**HYDRO-QUEBEC DISTRIBUTION'S  
RESPONSE TO THE RÉGIE'S REQUEST  
FOR INFORMATION NUMBER 1**

**Responses to the Régie's Request for Information Number****CONTEXT OF THE LAD PROJECT**

**Figure 3: Age Distribution of the Meters (2011)**

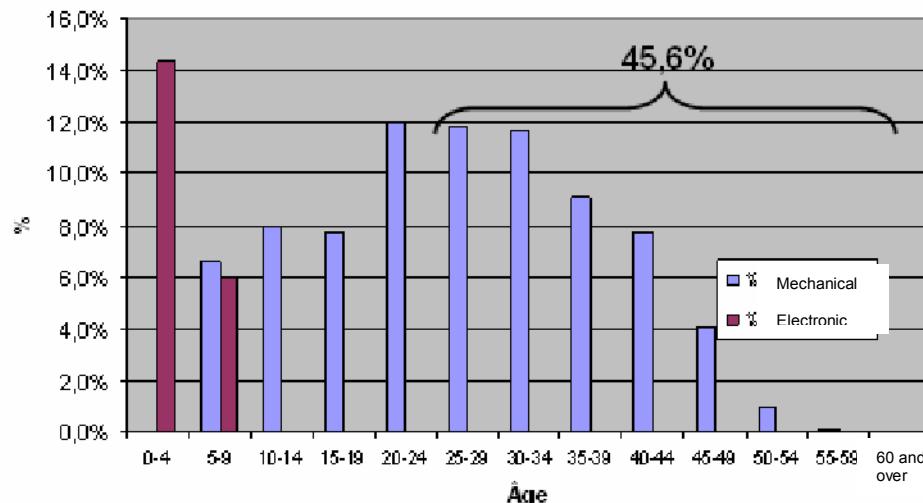
(v) “Figure 3 shows the age distribution of the current fleet of meters. It shows that more than 45% of the meters exceed their lifespan, set at 25 years for electromechanical meters and 15 years for electronic meters serving residential clients.” (emphasis added)

- 1.3** Please add more detail to the histogram from Figure 3 in order to show the proportion of electronic meters in the fleet and the distribution by age segment of the electromechanical meters and also, separately, the electronic meters.

**Answer:**

**Table R-1.3: Distribution of the fleet of meters by type and age segment**

From Figure 3, the Régie understands that while complying with Measurement Canada requirements, the Distributor's management of its fleet of meters has made it possible to have a fairly uniform distribution of the age of the fleet and also benefit from an effective lifespan of the meters that exceeds their accounting lifespan.
